ADDENDUM NO. 2 TO DRAWINGS AND SPECIFICATIONS FOR THE DEKOVEN TANKS REPLACEMENT

MID-PENINSULA WATER DISTRICT SAN MATEO COUNTY, CALIFORNIA

JULY 1, 2021

<u>APPENDIX – A3 MICROCLOR ON –SITE HYPCHLORITE GENERATION SYSTEM MC-300</u> UPDATED

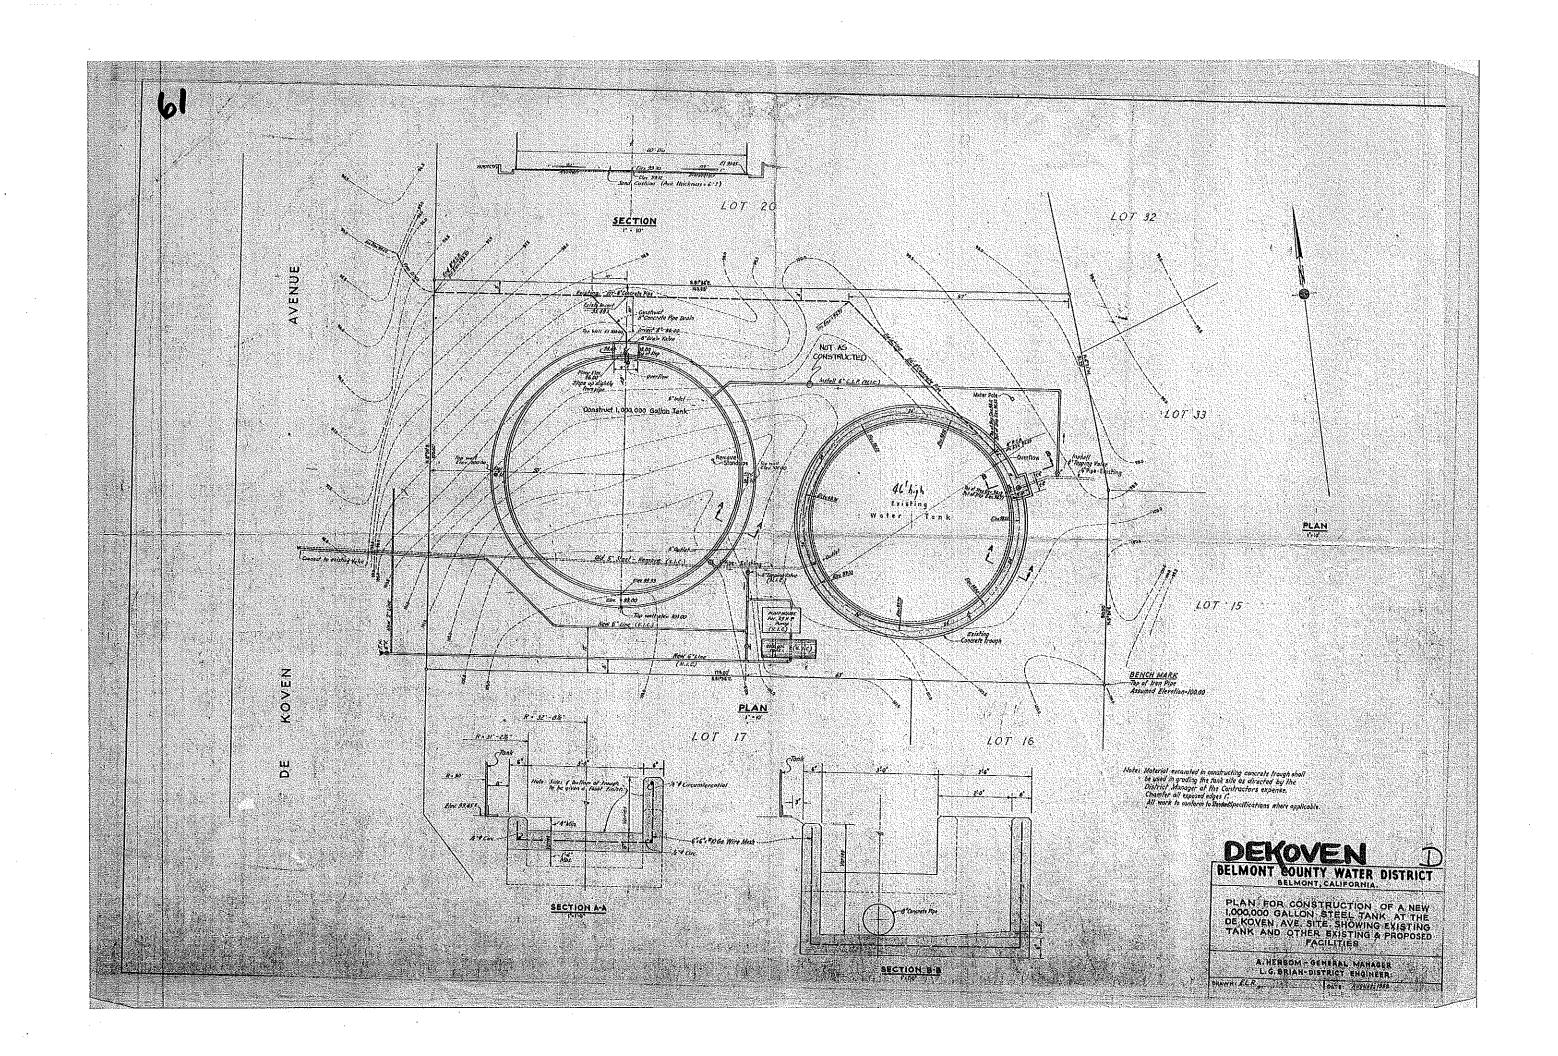
Replace A3 with the Monoclor RCS [®] Chloramine Management System Hypochlorite and LAS Dosing with WQS & PWM400 Mixer piping and instrumentation diagram dated 6/29/2021.
